**From:** [Symons, Brian D](#)  
**To:** [Sager, John E - DNR](#)  
**Cc:** [Saari, Christopher A - DNR](#); [Waite, Brian A - DNR](#); [Krul, Steve](#); [Kramka, Larry](#); [Jamie Mehle \(SWLP\)](#); [Joscelyn Skandel \(SWLP\)](#); [Gregory Prom \(MP\)](#)  
**Subject:** RE: [External] Remedial Action Construction Completion  
**Date:** Wednesday, May 29, 2024 10:19:53 AM  
**Attachments:** [MW-4B Well Construction Form.pdf](#)  
[As-Built Drawing B-5 Cross Sections Former Hortonsphere As-Built.pdf](#)

**From:** Sager, John E - DNR <John.Sager@wisconsin.gov>  
**Sent:** Wednesday, May 29, 2024 10:41 AM  
**To:** Gregory Prom (MP) <gprom@mnpower.com>  
**Cc:** Saari, Christopher A - DNR <christopher.saari@wisconsin.gov>; Waite, Brian A - DNR <brian.waite@wisconsin.gov>; Krul, Steve <Steve.Krul@foth.com>; Kramka, Larry <Larry.Kramka@foth.com>; Symons, Brian D <Brian.Symons@Foth.com>; Jamie Mehle (SWLP) <JMehle@swlp.com>; Joscelyn Skandel (SWLP) <jskandel@swlp.com>  
**Subject:** [External] Remedial Action Construction Completion

This email is a follow-up to our call on May 15, 2024 regarding the Upland Remedial Action Construction Completion report submitted for the SWL&P MGP site

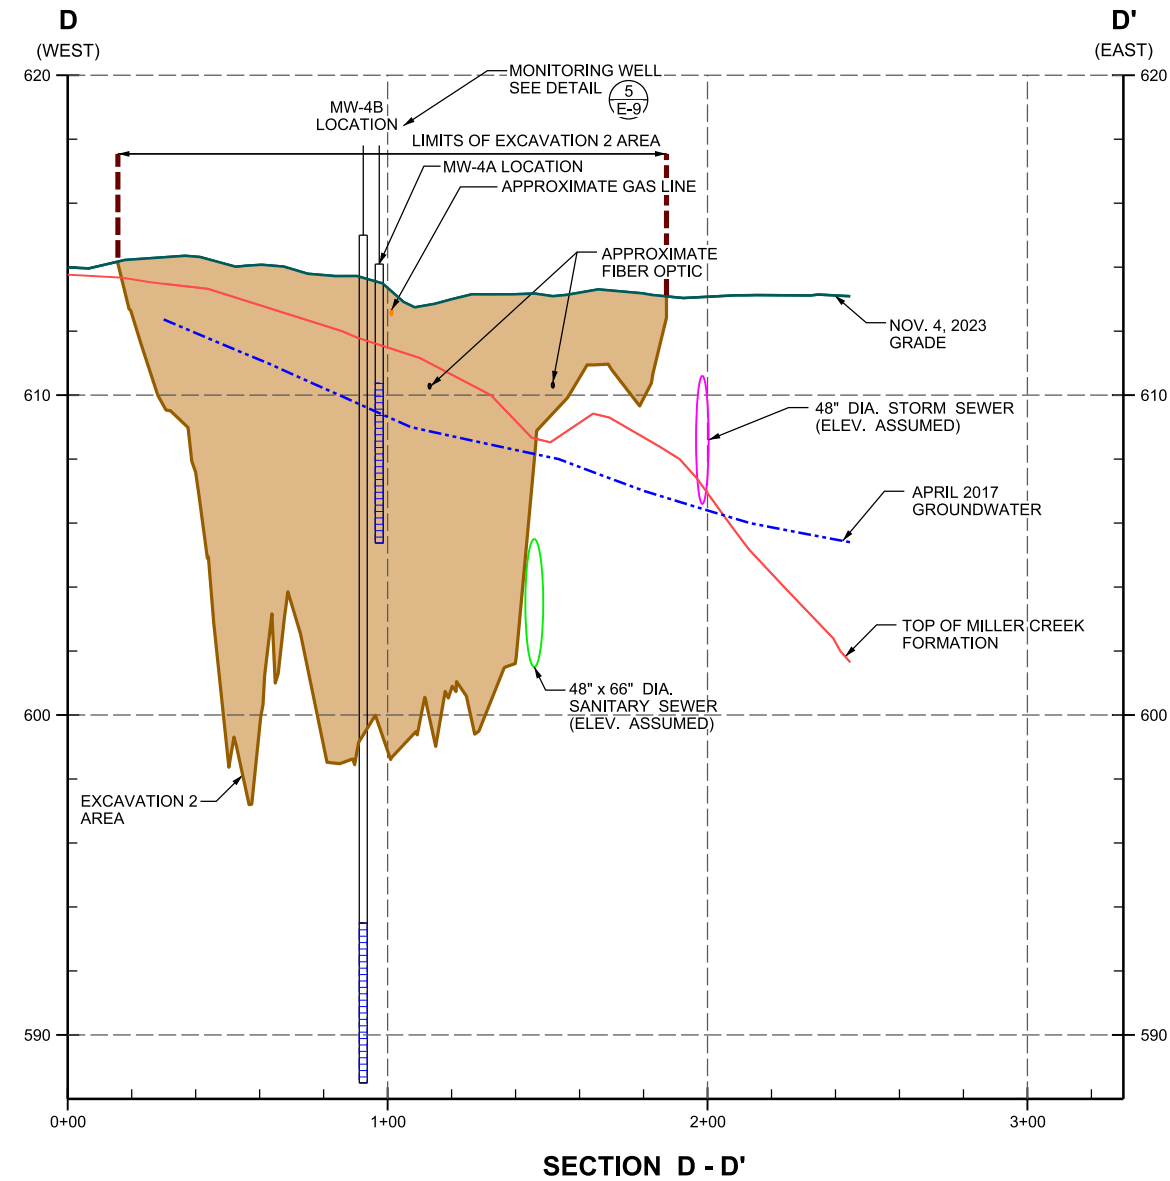
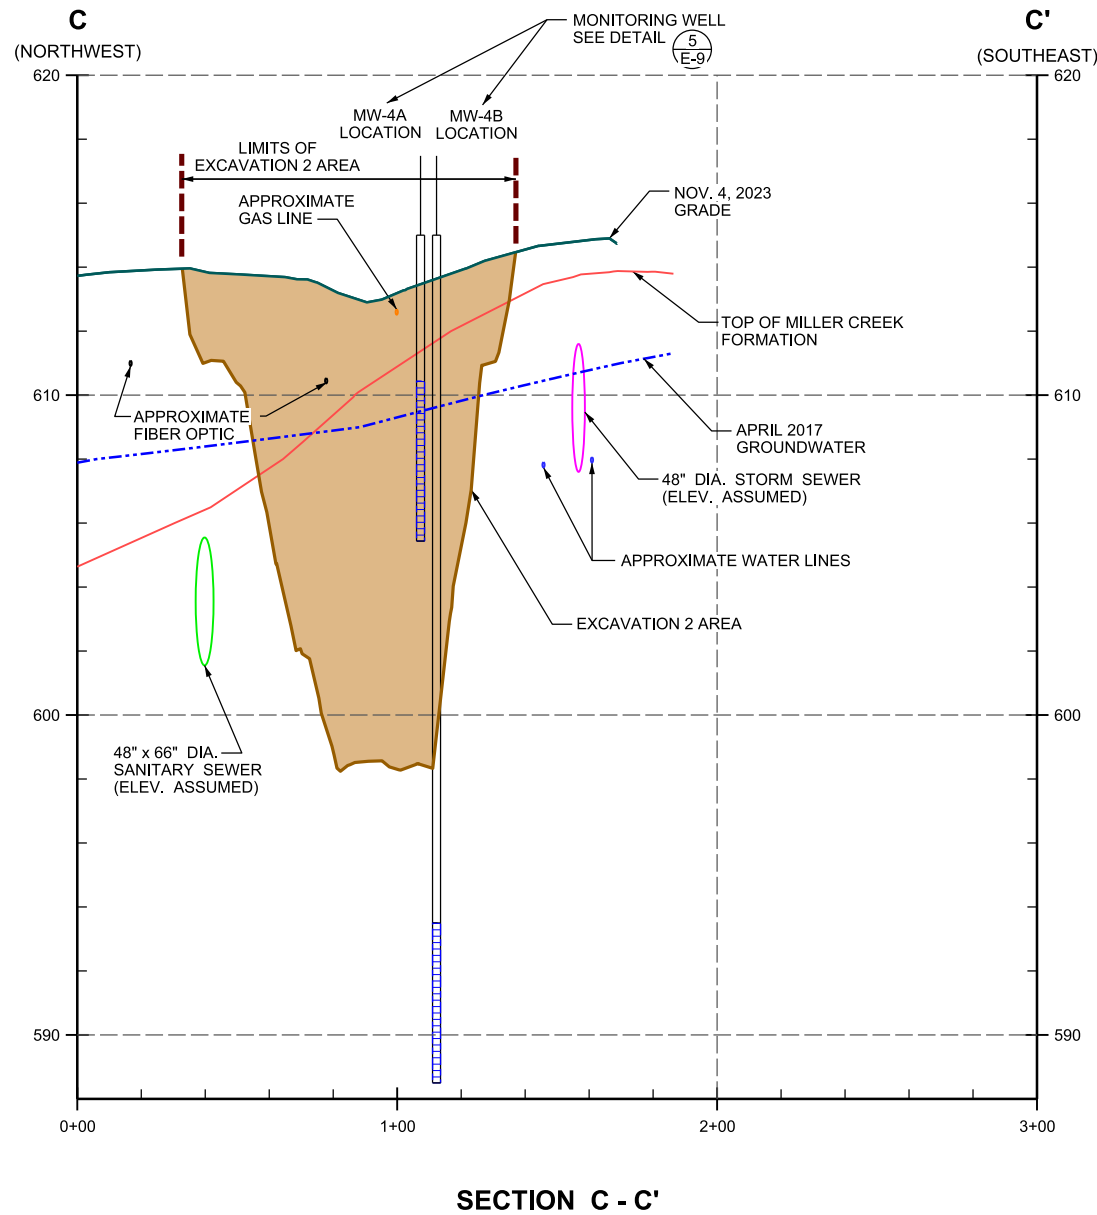
The groundwater sample results presented during the meeting included results from the replacement monitoring well MW-4B. This well appears to have been installed with its screened interval and filter pack extending into the ORC amended backfill for the Horton sphere excavation. It is our opinion this situation could allow groundwater, treated with ORC to enter the filter pack and screen of the well. Based on our previous discussions and comments expressed by the DNR in previous letters, the DNR expected this well be installed below the excavation and ORC backfill to evaluate groundwater contaminant concentrations vertically. With the investigation activities discussed above the DNR expects a piezometer be installed at the location of MW-4B (and potentially other areas of the site) to evaluate the vertical extent of contamination. This work could be conducted following an initial assessment.

Foth investigated the well construction at MW-4B, discussed this with Heather Hallett (Foth Project Geologist), and determined that the well was installed consistent with WDNR comments. After reviewing the MW-4B Well Construction Form (attached), Foth determined that the groundwater monitoring well construction shown on As-Built Drawing B-5 was not correct. Attached is a revised version of As-Built Drawing B-5 - Cross Sections Former Hortonsphere for your reference.
